# Service NOTIFICATION

## Coolant hose chafing

**SN-SECS-CT\_\_-03;**

**SN-SECS-CT2k-04**

**Fig. 1**

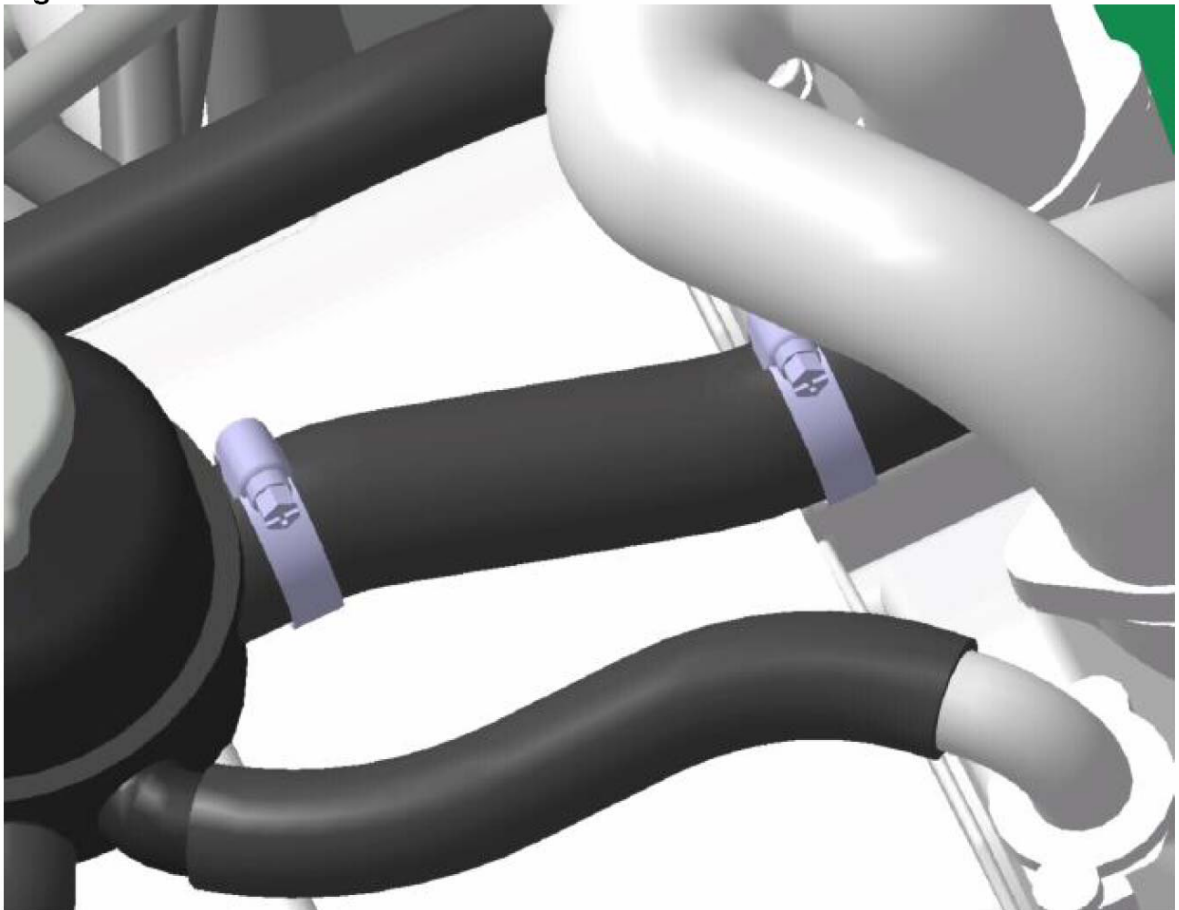
According to information from UK there can be a problem that one of cooling system rubber hose gets worn against cast inlet air manifold of the engine.

Aluminium pipe routed from cooling liquid expansion tank on the top of the engine under left cylinders air inlet manifold (see fig.1) down to radiator was modified to more simple shape utilizing one-plane bends. With that the distance from expansion tank to upper edge of aluminium tube increased from about 2 up to about 7 cm and clamp was moved outside (see fig.2).

Please check if you can see in your plane rubber hose fixing clamp installed outside the air inlet manifold, please check wearing of the rubber hose against the manifold. If the rubber hose is worn out without having an aluminium tube under it and being clamped between manifold and expansion tank, replace rubber hose and the aluminium tube to a longer one.
